Report to Planning Committee 19 January 2023
 Business Manager Lead: Lisa Hughes – Planning Development
 Lead Officer: Honor Whitfield, Planner, ext. 5827

Report Summary			
Application Number	22/02122/HOUSE		
Proposal	Part two-storey, part single-storey side and front extension and insertion of dormer windows		
Location	Sunray, Main Street, South Scarle, Nottinghamshire, NG23 7JH		
Applicant	Miss Sarah Davis	Agent	N/A
Web Link	22/02122/HOUSE Proposed ground floor and first floor extension Sunray Main Street South Scarle Nottinghamshire NG23 7JH (newark-sherwooddc.gov.uk)		
Registered	15.11.2022	Target Date Extension To	10.01.2023 20.01.2023
Recommendation	That Planning Permission is <u>APPROVED</u> subject to the Conditions detailed at Section 10.0

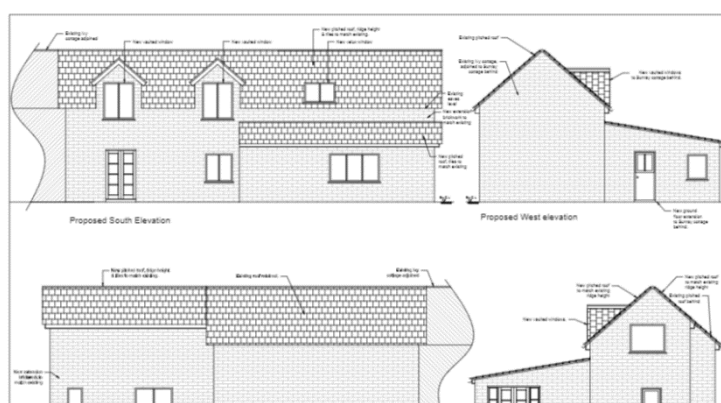
Initially the proposal included a large two-storey extension to the side of the dwelling with a matching ridge and eaves height to the property (see plan extract below) in addition to a large single storey extension and two dormer windows. The length of the side extension was proposed to be similar to the length of the existing cottage and the design, massing and proportions were considered to be unbalancing to this traditional two bay cottage. The single storey extension to the front was also considered to disrupt the linear form of the cottage, adding a deep/bulky front projection. Cumulatively the extensions to add a significant additional footprint to the cottage and were considered to be incongruous in design, disproportionate and harmful to the character of this NDHA.

Concerns were also raised in relation to the dormer windows which were considered to be larger in scale to those traditionally found on historic buildings and added further bulk to the cottage. In respect of dormer windows, the Householder SPD explains that the introduction of dormer windows into a roof can give rise to significant impacts on the appearance of a dwelling and the character of the surrounding area. Use of smaller pitched roof dormers, balanced in terms of their proportions and positioning with the hostdwelling is encouraged and overall, dormers should be balanced with the proportions of the hostdwelling and reflect its vertical proportions.

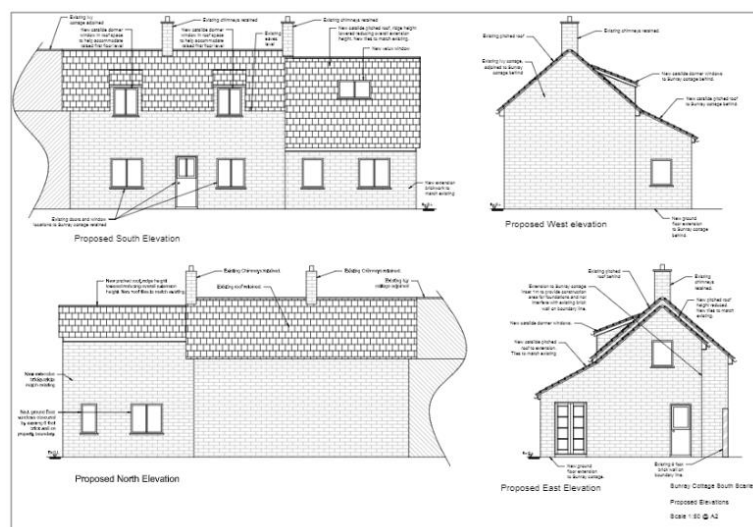
Following negotiations to overcome Officer's concerns, amended plans were received which have reduced the scale (width and length) of the proposed extensions and re-designed the style of the extension to a cat-slide addition (which is a more traditional style of extension to gain additional footprint). The amended plans below show the two-storey extension would now sit below the existing ridge height of the dwelling, resulting in a more subservient appearance. The use of a cat-slide design to include a front single storey extension also assists in reducing the overall bulk and massing of the extensions. The dormer windows have also been amended to cat-slide dormer windows of smaller proportions which now respect the character and proportions of the hostdwelling, and new windows have been amended to reflect the style and proportions of the existing windows.

The scheme also includes the removal of the existing front (modern) lean-to porch which is currently considered to be a detracting feature of the dwelling – it is considered that this would be a heritage benefit of the scheme that could help to balance out and limit the harm from the cat-slide extension projecting past the front elevation which is not typical for a linear

cottage range. Given the retention of this lean-to porch in addition to the cat-slide front extension would result in a cluttered principal elevation and the removal of this porch helps reduce the level of harm arising from the cat-slide extension it is considered reasonable to condition that this porch must be removed prior to occupation of the new extension.
